Final Focused Feasibility Study Saranac Street Former MGP Site Operable Unit 1 (OU-1) Plattsburgh, New York NYSEG (New York State Electric & Gas Corporation)

Re: Draft Feasibility Study Report, Plattsburgh (Saranac Street) Former Manufactured Gas Plant Site Operable Unit 1

Re: Draft Feasibility Study Report Plattsburgh (Saranac Street) Former Manufactured Gas Plant Site Operable Unit 1

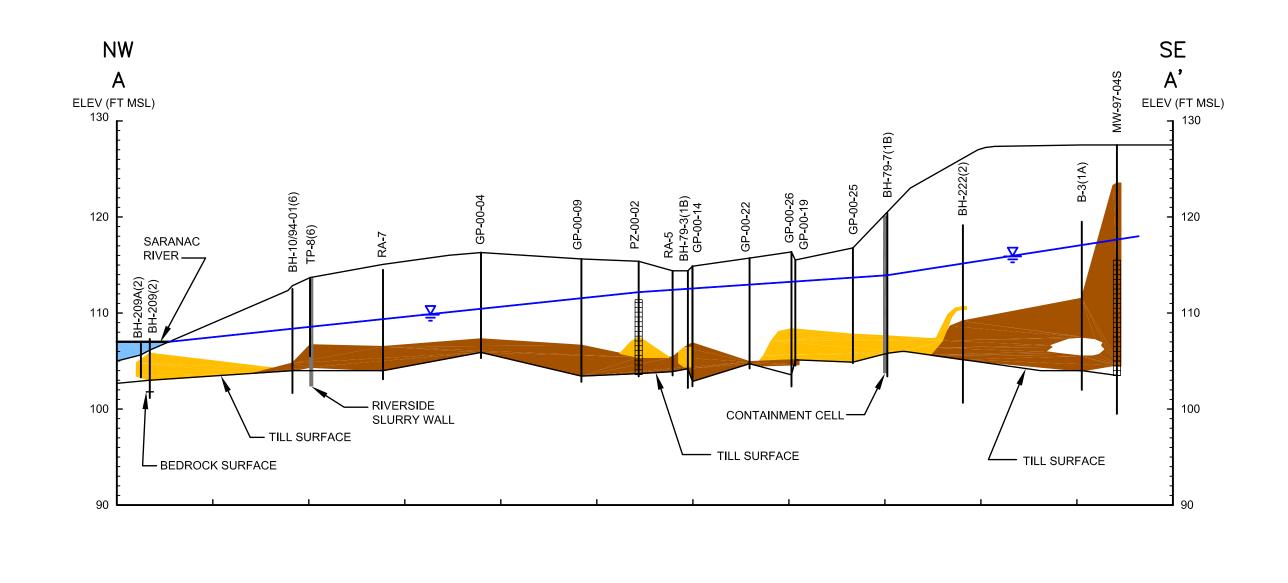
Figure 6 also fails to accurately depict the extent of contamination along the west side of the site. The gap shown on this map between the small zone of contamination north of the wood deck bridge and the main body of contamination farther downstream is directly contradicted by Plate 4 of the Operable Unit 2 RI. Tar contamination was reported in sediments along the river bank from every transect in this area, except for one. The one exception occurred in an area (transect K1) where there appeared to be no sediment. NYSDEC personnel also found an intermittent seep in this area during one field visit. Consequently, the Department considers the entire river bank along the western side of the site to be contaminated. All remedial alternatives which propose to excavate river sediments must be revised to include this area.

Figure 6 also fails to accurately depict the extent of contamination along the west side of the site. The gap shown on this map between the small zone of contamination north of the wood deck bridge and the main body of contamination farther downstream is directly contradicted by Plate 4 of the Operable Unit 2 RI. Tar contamination was reported in sediments along the riverbank from every transect in this area, except for one. The one exception occurred in an area (transect K1) where there appeared to be no sediment. NYSDEC personnel also found an intermittent seep in this area during one field visit. Consequently, the Department considers the entire riverbank along the western side of the site to be contaminated. All remedial alternatives, which propose to excavate river sediments, must be revised to include this area.
